P 34163

SEWAGE DISPOSAL SYSTEM

A 30926

SUBDIVISION Patapsco Park Estates ROAD 9048 Furrow Avenue LOT 17 Section 3

PLOT PLAN

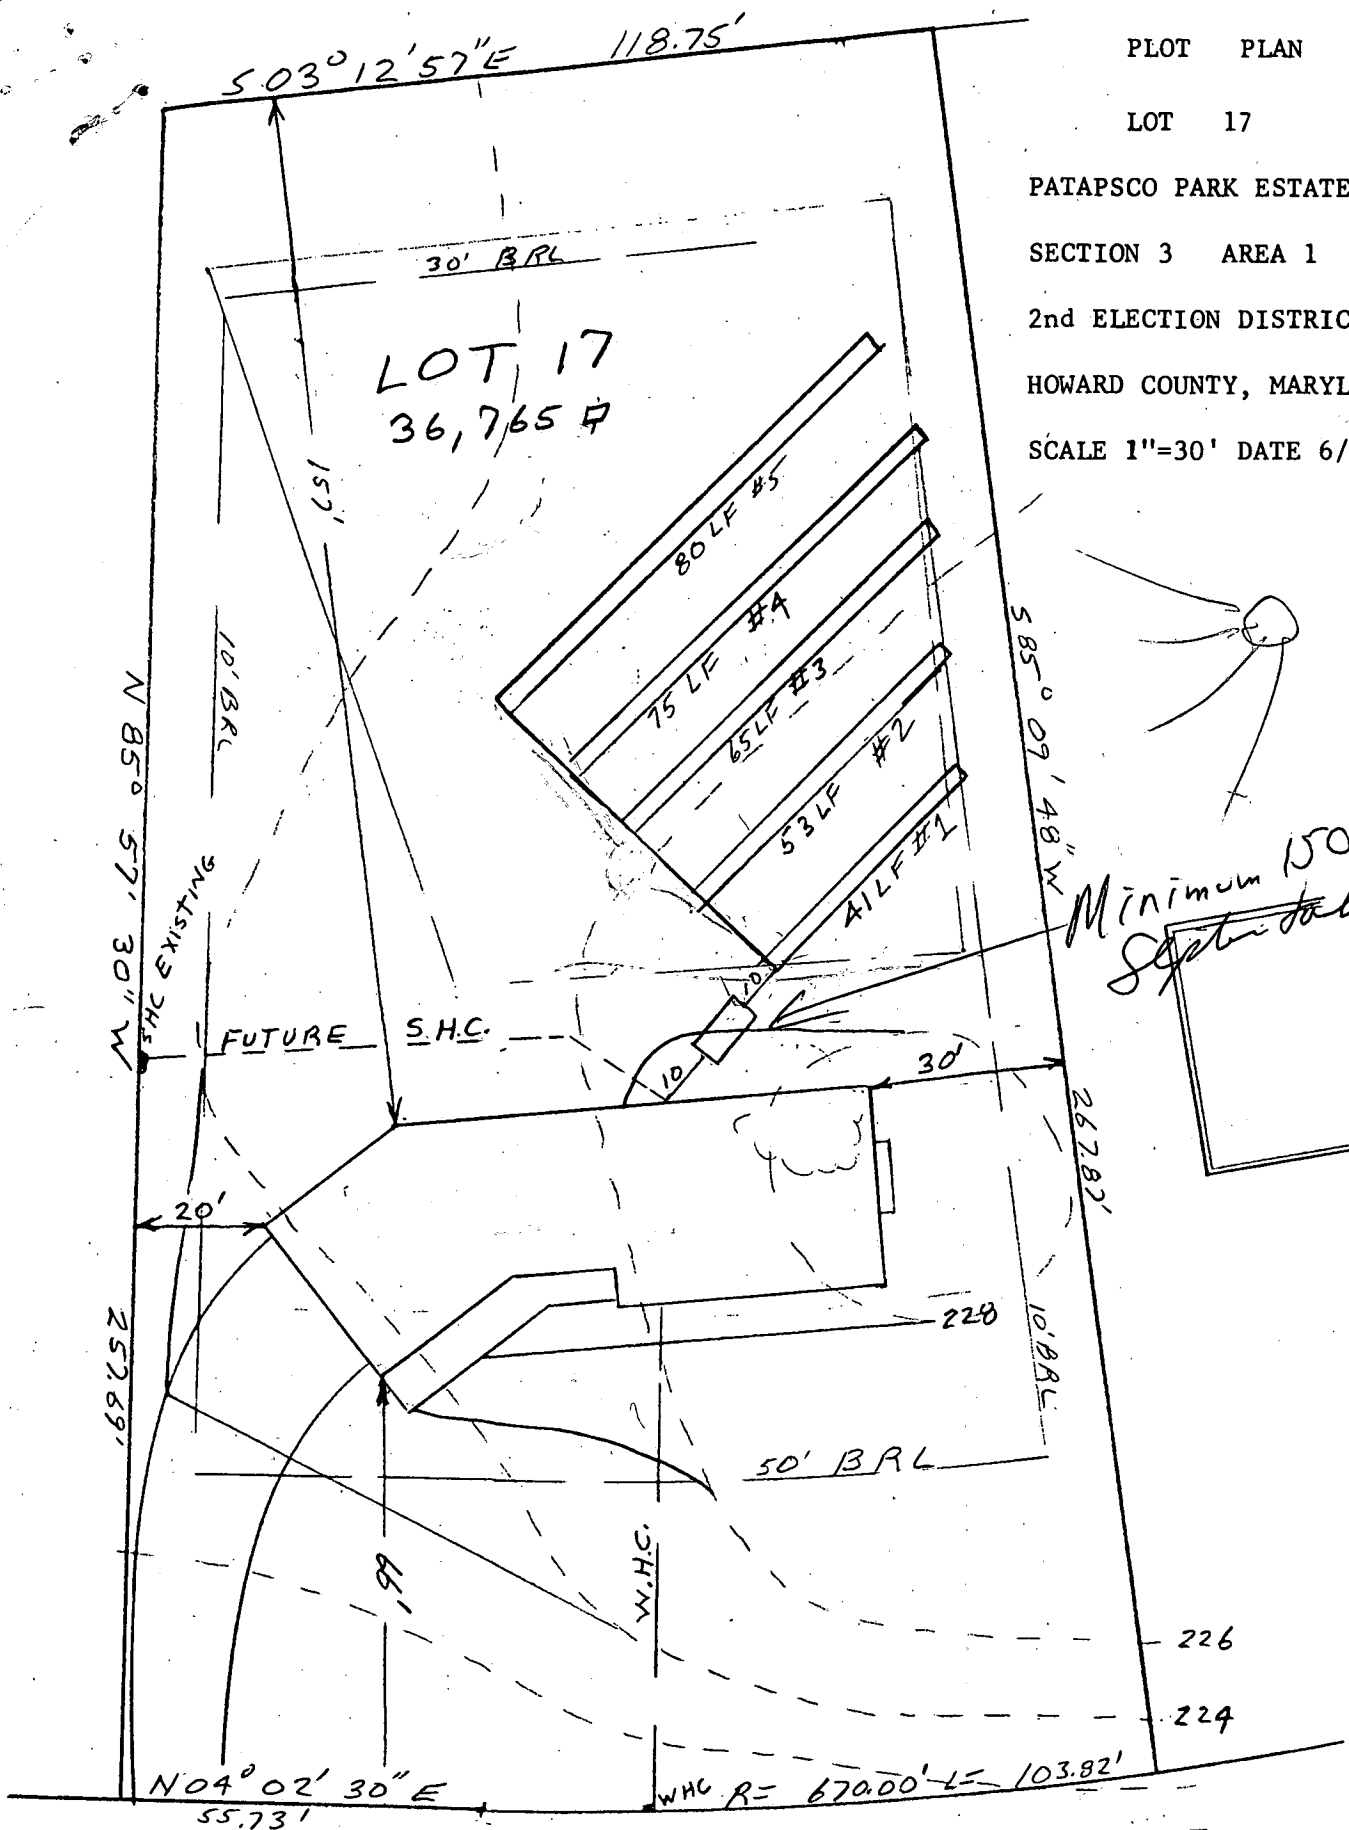
HOUSE CONNECTION & CLEANOUT NEEDED, CW, 8-1-84

REMARKS 8-1-84 NEEDS CLEANOUT & HOUSE CONNECTION

WHAT ABOUT DIST BOX & T'S? CW

6/26/84
 Sketch of
 F.S.

Minimum 1500 gallon
 Septic tank
